UNITED STATES PATENT AND TRADEMARK OFFICE

| APPLICATION NO. | FILING DATE | FIRST NAMED INVENTOR | ATTORNEY DOCKET NO. | CONFIRMATION NO. |
|-----------------|-------------|----------------------|---------------------|------------------|
| 10/792,351 | 03/03/2004 | Diana Lynne Gann | 9567 | 4523 |

| Office Action Summary | Application No. 10/792,351 | Applicant(s) GANN ET AL. | |

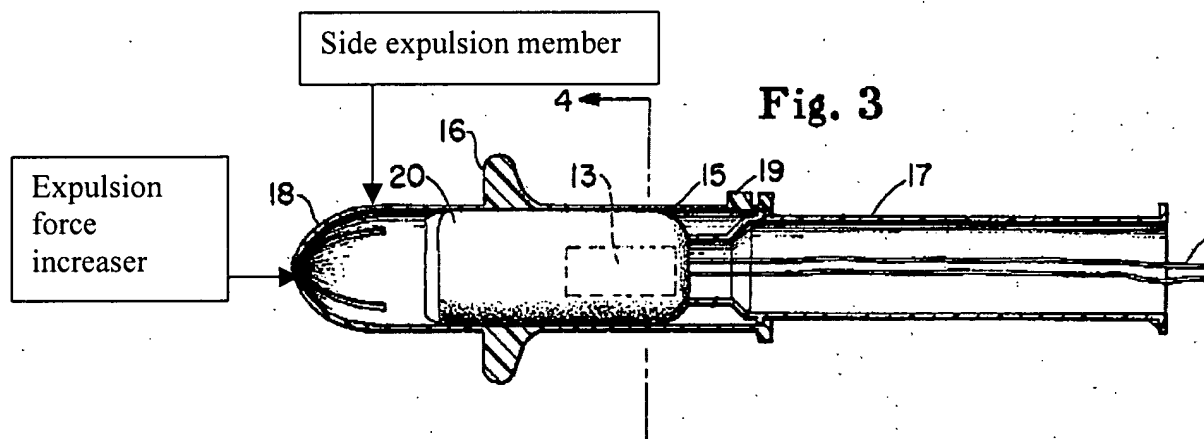
Regarding claims 1, 11 and 14, Kokx teaches a tampon (20) and a tampon applicator (15) in combination for expulsion of said tampon (20) into a vaginal cavity of a female user, comprising:

said tampon applicator (15) comprising a tampon holder tube (15) and a plunger (17);

said tampon holder tube (15) comprising a hollow interior portion, an interior surface, an exterior surface, a longitudinal axis, an outer perimeter, a first end dimensioned for insertion into said vaginal cavity, a second end positioned oppositely to said first end, an end expulsion force increaser positioned at said first end of said tampon holder tube (15), comprising at least one side expulsion member positioned at said first end of said tampon holder tube (15),

said tampon (20) comprising a fluid permeable bag (12) and absorbent material (11) loosely dispersed within said permeable bag (12), said tampon (20) being housed within said hollow interior portion of said tampon holder tube (15) in a pre-expelled position; and

said plunger (17) being slidably mounted in said hollow interior portion of said tampon holder tube (15), said plunger (17) being adapted to expel said tampon (20) through said end expulsion force increaser (see marked figure 3, below).

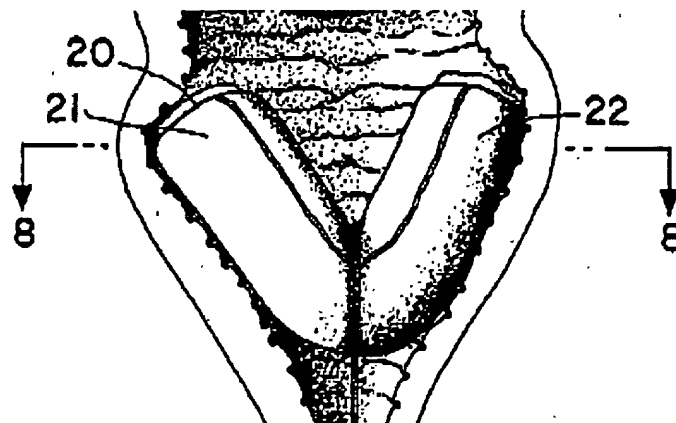
Regarding claims 12 and 13, Kokx teaches that the axis of the tampon reorients itself once it has been expelled (figure 7, below).
